## ADDENDUM #2

**To:** Demolition and Abatement Contractors  
**For:** Iowa Juvenile Home Environmental Remediation and Demolition Services  
**Project:** 13227024  
**From:** Terracon Consultants, Inc., on behalf of the City of Toledo, Iowa  
**Subject:** Addendum #2  
**Date:** September 20, 2022

Iowa Juvenile Home ■ Toledo, Iowa  
September 20, 2022

**Photo 1.** Skow Transite.

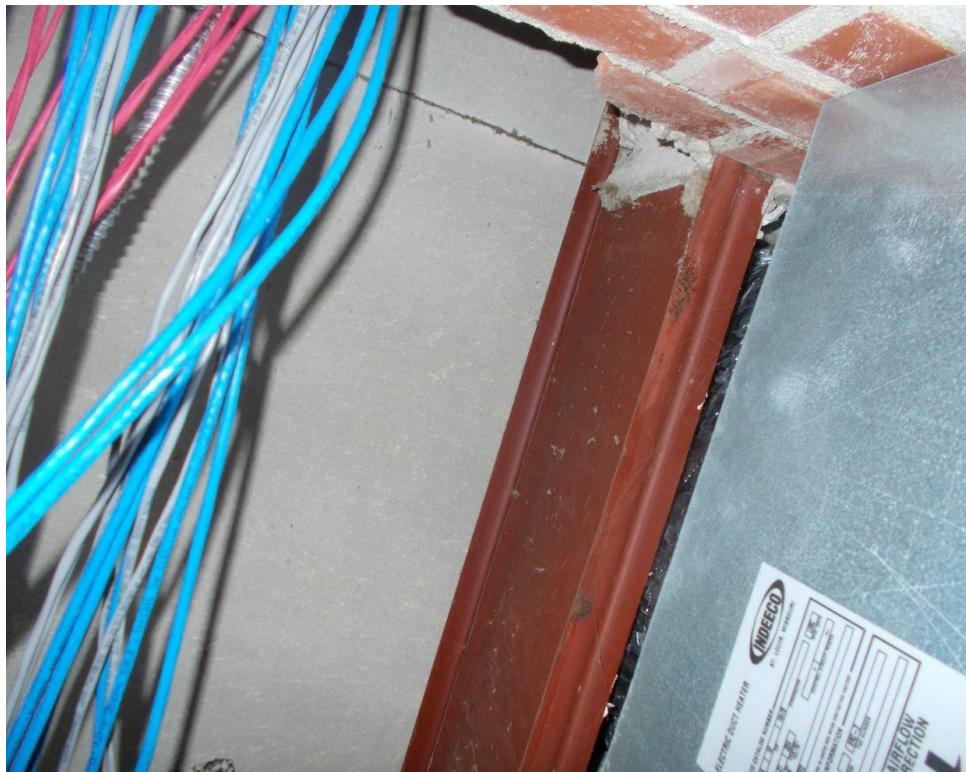
**6. Note:** Skow Cottage contains asbestos containing cement board (Transite) and an asbestos containing adhesive atop of structural steel and below roofing materials. Based on additional investigation completed on September 19, 2022 on Skow Cottage, the contractor should be aware that both the roofing materials and the plaster ceilings below (interior side) may need to be removed to access and abate the asbestos containing materials, as shown in Photo 1, below. Duct work, cabling, piping, fire systems, demising walls, drop ceilings, ACT, and other materials may need to be removed to complete ceiling demolitions and Transite abatement. The roof matrix of Skow Cottage appears to consist of the following (from top to bottom): rubber membrane>gypsum board>4-inches of foam insulation> tar/built-up roofing >1-inch fiber board>ACM adhesive (black)>ACM Transite, see photo 2 below. The contractor will also likely need to remove the fiberboard as ACM waste.
